DART SERVICE INSTRUCTION

TO AMEND INSTALLATION INSTRUCTIONS II135-21 REV. J
AND INSTRUCTIONS FOR CONTINUED AIRWORTHINESS ICA135-21 REV. F
OR LATER APPROVED REVISIONS

REF. TCCA STC: SH21-29
REF. FAA STC: SR02307LA
REF. EASA STC: 10031793
REF. AFAC STC: IA-751/2021

Figure 1 - Support Angle Installations

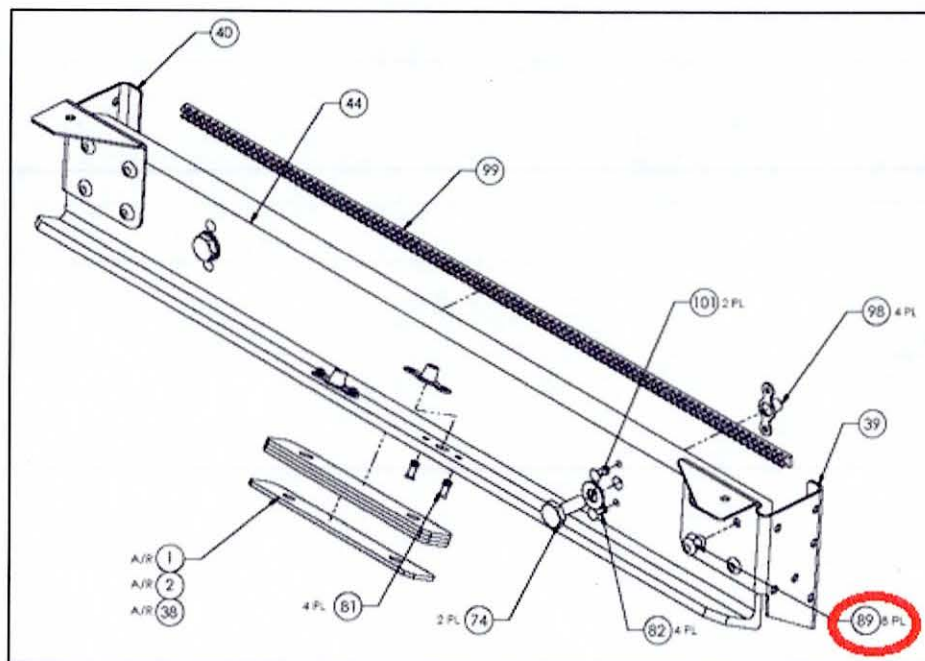
Step 7 from Section 4.0 of II135-21 cannot be accomplished due interference from existing equipment installed on the aircraft. Also, there is not enough clearance to insert the required tool to drive some of the rivets in place.

With reference to Figure 1 of this DSI, it is acceptable to install the Support Angle P/N 647.1915 (F/N 44) and Gusset P/Ns 647.1814/1815 (F/N 39 and 40) using shear Hi-Loks and Hi-Lok Collars in lieu of 601.1915 Rivets (F/N 89). Figure 1 and the tables on page 2 this DSI clarify changes to parts shown in Figure 22 and Table 10 of II135-21. The changes are circled in red.

IS:

F/N	Qty (7332)	P/N	Description
89	8	HL18PB5-3* HL70-5*	Hi-Lok Hi-Lok Collar

*: Acceptable alternate P/Ns: HL18PB6-3 (Hi-Lok) and HL70-6 (Hi-Lok Collar)
